AMENDMENT SHEET

Planning Committee 2 August 2018

AMENDMENTS OF CONDITIONS AND REPRESENTATIONS RECEIVED

7.1 180733 – Land adjacent to Armoury Road, West Bergholt

Figure 7.1 Mfs

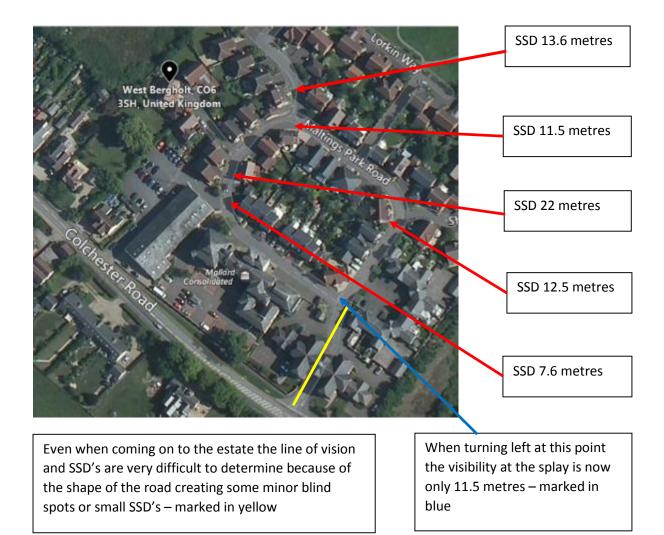
This would indicate that there is a risk of harm at this point, very close to the entrance of the proposed development. A point to note that these pictures were taken when there were no cars parked on the street.
